W3F1-2004-0029

SUBJECT: Supplement to Amendment Request NPF-38-249,
Extended Power Uprate
Waterford Steam Electric Station, Unit 3
Docket No. 50-382
License No. NPF-38

**Response to Request for Additional Information
Related to the Extended Power Uprate**

**WESTINGHOUSE ELECTRIC CORPORATION
CALCULATED CAPABILITY CURVES
Waterford Unit #3 SES - Curve No. 660485**

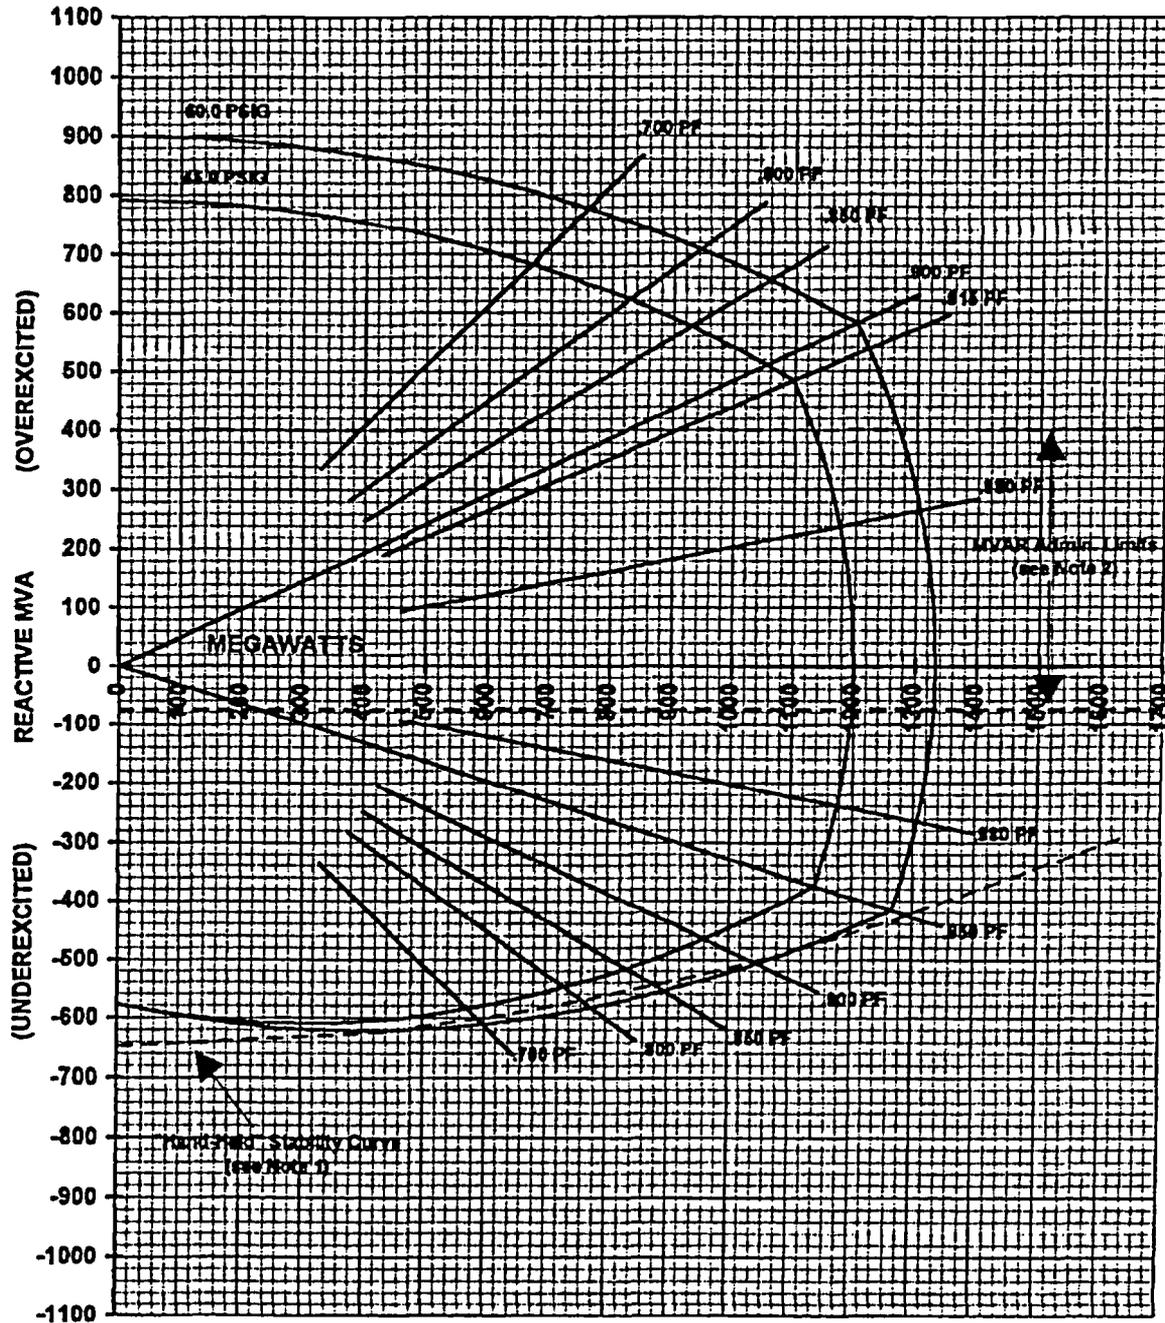
Address the compensatory measures that the licensee would take to compensate for the depletion of the nuclear unit megavolt-amperes resistive capability on a grid-wide basis.

The present generator design is for a 1333.2 MVA (see attached generator capability curve) rating with the main transformers rated for 1200 MVA (FSAR Section 8.2.1 & Table 8.2-1). The generator is being rewound to restore the original design (i.e., 1333.2 MVA) which can accommodate EPU conditions. The main transformers and switching station are being modified as necessary to support the full 1333.2 MVA generator post uprate conditions as discussed in power uprate report (PUR) Section 2.3.2.2.

The pre-uprate nominal generator gross output is 1153 MW. The generator reactive output existing Administrative Limit is 400 MVAR which results in a power factor of 0.954.

The EPU electrical increase is targeted at 68 MW. The system interconnection and offsite studies assumed a conservative output of 1249 MW for the post-uprate generator gross output. The generator nominal reactive output capability for this output would be 466 MVAR or a power factor of 0.937. The analyses assumed a conservative value of 400 MVAR during the evaluation.
